Access Compliance Report Public Rights-of-Way (Island Curb Cuts)

Main Street: FAUNA_DR		Cross Street: CHIQUITA_CANYON_DR		Location:	S
ADA ID: CCRK211124125639	Curb Cut Type: MedianRefuge2	Initial Pass/Fail: Pass	Overall Compliance: No	Severity Score:	10
Codes/Mitigation Info/Possible Solution			Field Measurements/Component Compliance

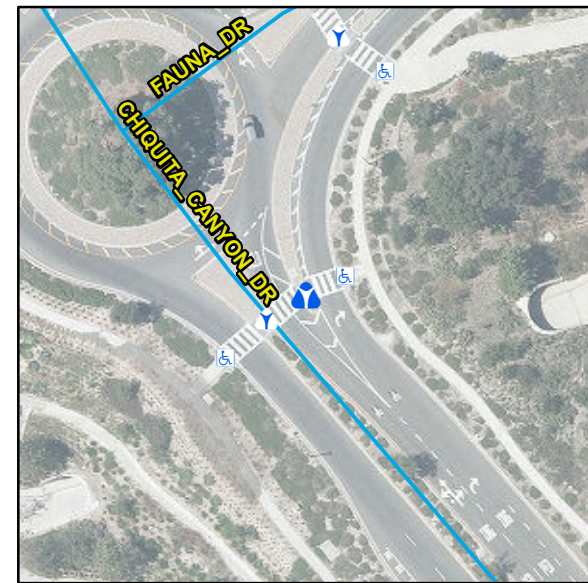
Compliance	Description	Data	Compliance	Description	Data
No	Refuge 1 Length (In)	34	Yes	Guttter 1 Ponding	No
Yes	Refuge 1 Width (In)	96	Yes	Gutter 1 Lip Ht (In)	0
Yes	Refuge 1 Slope (%)	3.6	No	Gutter 1 Slope (%)	5.8
Yes	Refuge 1 Cross Slope (%)	2.7	No	Gutter 1 Cross Slope (%)	2.1
N/A	Painted Cross Walk 1	Yes	No	DWS 1 Provided	Yes
	Cross Walk 1 Direction	W	N/A	DWS 1 Contrast	Yes
	Cross Walk 1 Width (In)	152	N/A	DWS 1 Length (In)	34
Yes	Refuge Inside Cross Walk 1	Yes	N/A	DWS 1 Full Width	Yes
	Road 1 Slope (%)	3.7	N/A	DWS 1 Offset (In)	0
	Road 1 Cross Slope (%)	2.3			N/A
No	Refuge 2 Length (In)	34	Yes	Guttter 2 Ponding	No
Yes	Refuge 2 Width (In)	96	Yes	Gutter 2 Lip Ht (In)	0
Yes	Refuge 2 Slope (%)	3.7	No	Gutter 2 Slope (%)	6.8
Yes	Refuge 2 Cross Slope (%)	2.6	Yes	Gutter 2 Cross Slope (%)	0.6
N/A	Painted Cross Walk 2	Yes	No	DWS 2 Provided	Yes
	Cross Walk 2 Direction	E	N/A	DWS 2 Contrast	Yes
	Cross Walk 2 Width (In)	152	N/A	DWS 2 Length (In)	34

Remove & Replace Entire Refuge. Remove & Replace Gutter.
